REQUEST FOR A SEALED SOURCE OR  
DEVICE EVALUATION

TOTAL NUMBER OF REVIEW HOURS	NOTES <b>Amendment request to registration NR-1121-S-101-S for brachytherapy LS-1.</b>
NUMBER OF DEFICIENCY LETTERS	
NUMBER OF DEFICIENCY CALLS

Re: Amendment to the Registration Certificate for BrachySeed™ – LS-1

ATTACHMENT 2

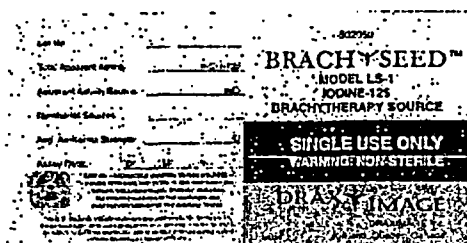
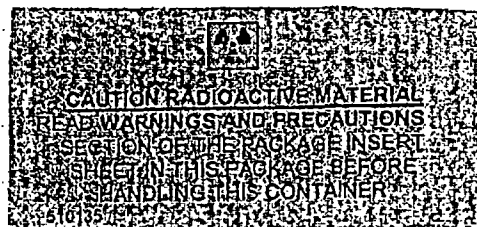
REVIEWER NOTE: The label shown in Attachment 2 is an example of the label. New labels must have the current wording of 10 CFR 32.74(a)(3) and should have the current address of the manufacturer or distributor.

This amendment proposes a change to the labels that are applied on the lead pot in which the brachytherapy sources are shipped. The change consists of the following:

- 1) Addition of our United States address in Williston, Vermont;
- 2) Correction of the references to the applicable regulations;
- 3) Addition of an alternate outer label for BrachySeeds that are supplied sterile.
